**PLANNED UNIT DEVELOPMENT  
& SUBDIVISION STAFF REPORT****Date: April 17, 2008****DEVELOPMENT NAME**Downtown West Subdivision, Unit Six, Resubdivision of  
Lots 34, 35, 36 & 37, Resubdivision of Lots 1 & 2**SUBDIVISION NAME**Downtown West Subdivision, Unit Six, Resubdivision of  
Lots 34, 35, 36 & 37, Resubdivision of Lots 1 & 2**LOCATION**4344 Downtowner Loop South  
(North side of Downtowner Loop South, 300'± East of  
Downtowner Loop West)**CITY COUNCIL  
DISTRICT**

**CONTEMPLATED USE**Planned Unit Development Approval to allow two  
buildings on a single building site.**TIME SCHEDULE  
FOR DEVELOPMENT**

# SITE PLAN

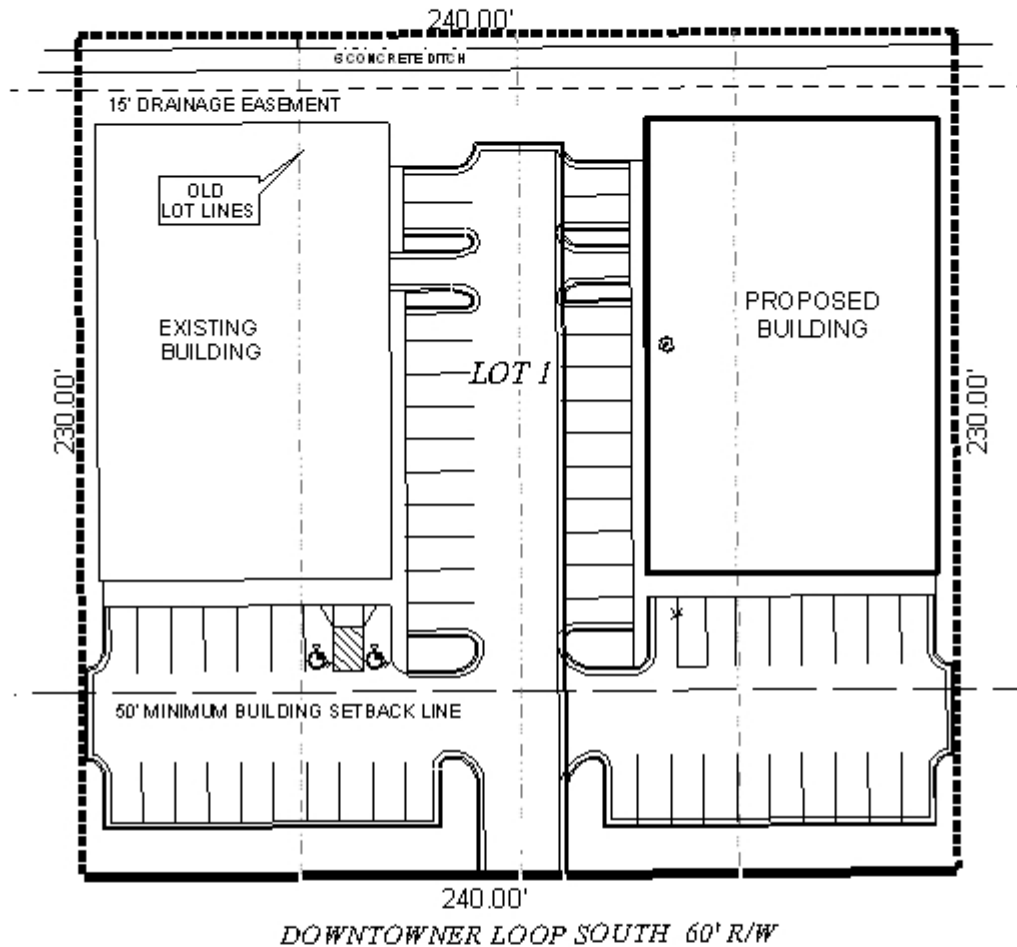
Regarding the PUD, the site plan submitted indicates an existing commercial office building and a proposed second office building for the site. No narrative was submitted giving a detailed description of use for the proposed building; however, the application states that the construction will begin immediately following approvals. The site plan submitted indicates all property line setbacks to be compliant, and site coverage is determined to be compliant graphically, however, no site coverage calculations are given. Internal circulation and parking is indicated, and no indication of truck loading/unloading, if any, is indicated. Only the existing curb cut to Downtowner Loop South is shown to remain. There are no parking calculations provided based on internal square footage uses of the buildings, and no landscaping areas and tree plantings are

shown or calculations provided. No storm water detention area is indicated, but no verification is furnished that such would not be required. No dumpster is depicted on the site plan. If a dumpster is proposed, it should be depicted on the site plan, or a statement should be provided indicating that no dumpster will be included as part of the development.

- 1) inclusion of a narrative giving a detailed description of the use of the proposed building and a timetable for expansion;
- 2) inclusion of calculations for site coverage, parking ratios based on internal uses of buildings, and for landscaping and trees;
- 3) depiction of parking, internal circulation, dumpster location (if any), truck loading/unloading (if any), and storm water detention (if any); and
- 4) submittal of two copies of the revised site plan to indicate all improvements based on the preceding conditions.
